MCPHERSON QUARRY

Thank you for a copy of the request for further information on the McPherson Quarry development as set out in the letter from Marshall Day Acoustics dated 29 July 2019 on behalf of the Waikato District Council. The following sets out the questions with our response.

Figure 1. Managed fill + quarry operating, dB L_{Aeq}

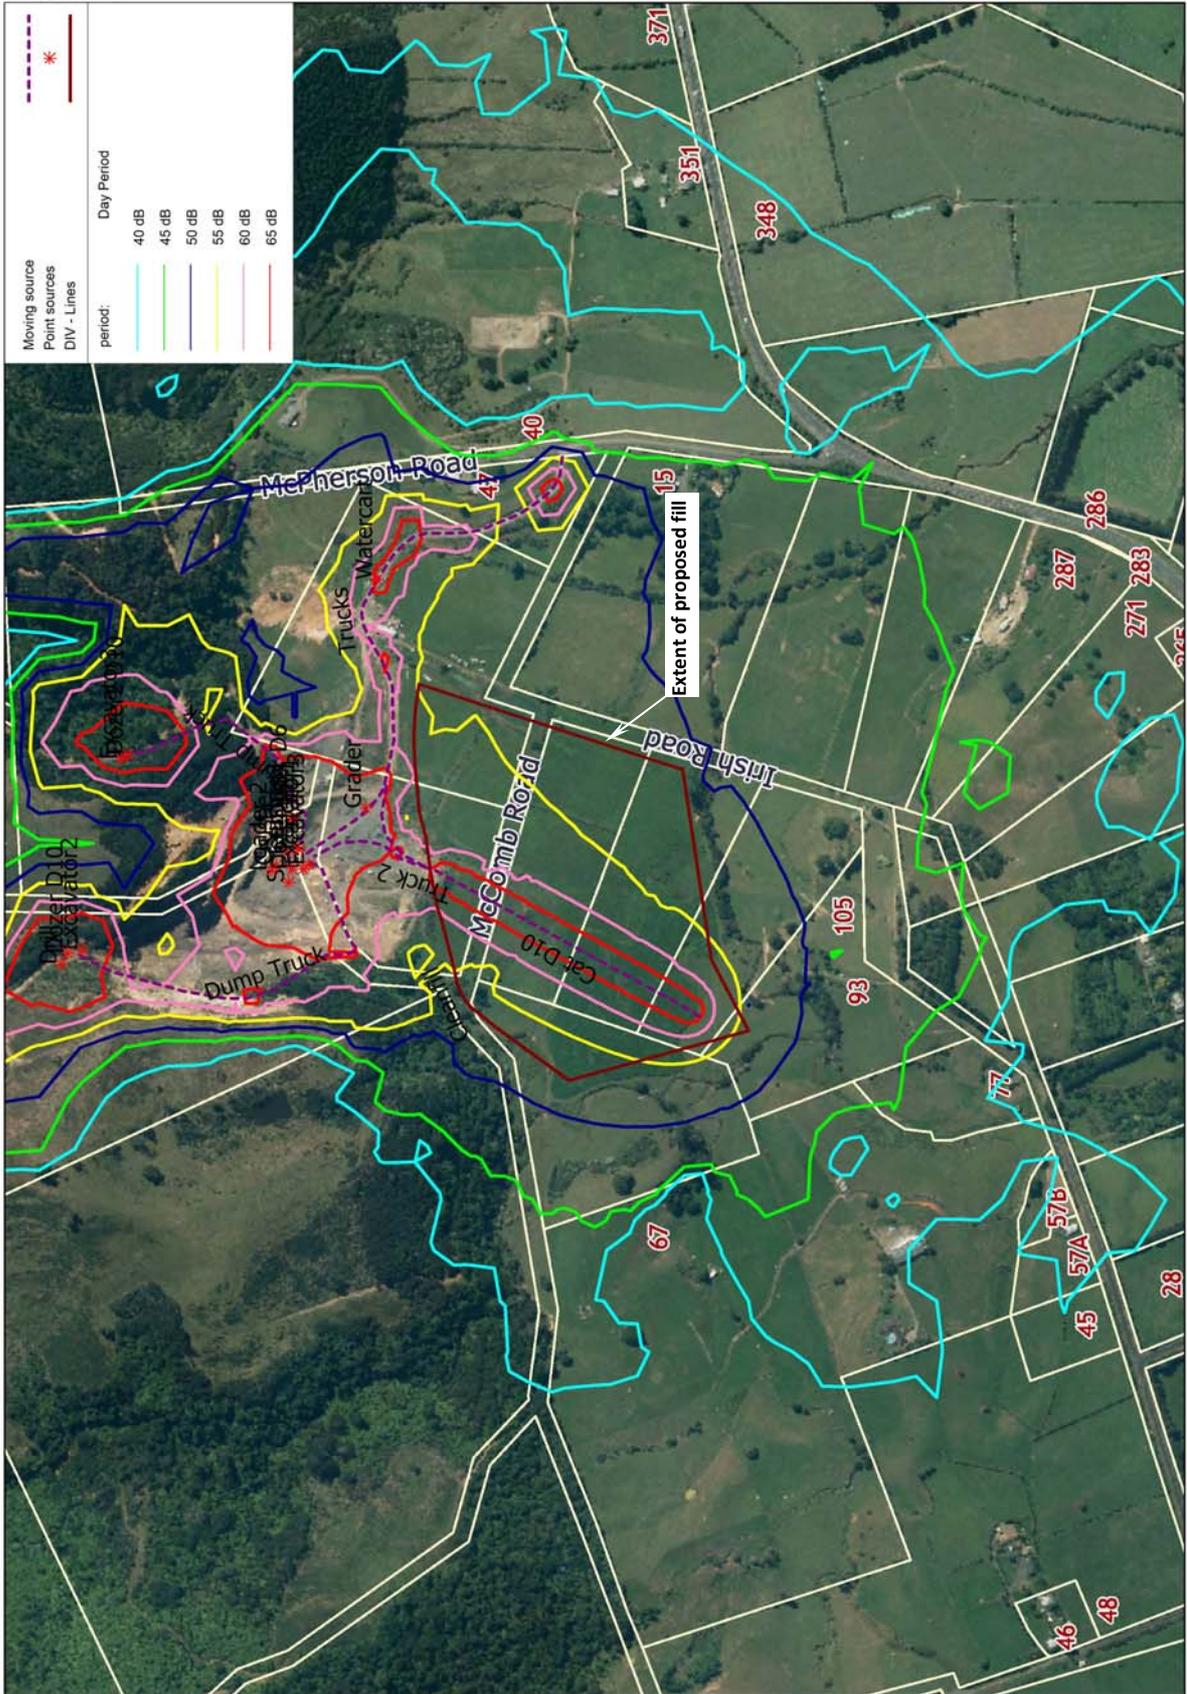
- (iii) *Assessment of overburden and clean fill activities south of the quarry*

Noise from the quarry operating plus the operation of the proposed managed fill has been assessed. There will not be any additional trucks to the site due to the managed fill as only trucks backfilling will import the fill. The fill will be tipped at a tip head and pushed to the fill position using a D6, D8 or the D10 bulldozer, the machine used will be dependent on the material being handled. The assessment has assumed the noisiest machine (D10) pushing the maximum distance to a point closest to the dwellings. At the closest point to the dwellings the managed fill will be lower than further back where there is more height to the fill. The position selected for the assessment is at a height of approximately 5m above ground level although checking has shown there will be line of sight to the closer dwellings at this height. Although the height of the fill increases to a maximum of 30m the increased distance to the dwellings when at this height results in a lower level being experienced at the receiver position.

The predicted noise contours when operating the managed fill, as set out above plus the closer area of the quarry, are shown on Figure 1. As the quarry and fill both progress to the north the noise that will be experienced by the residents will reduce.
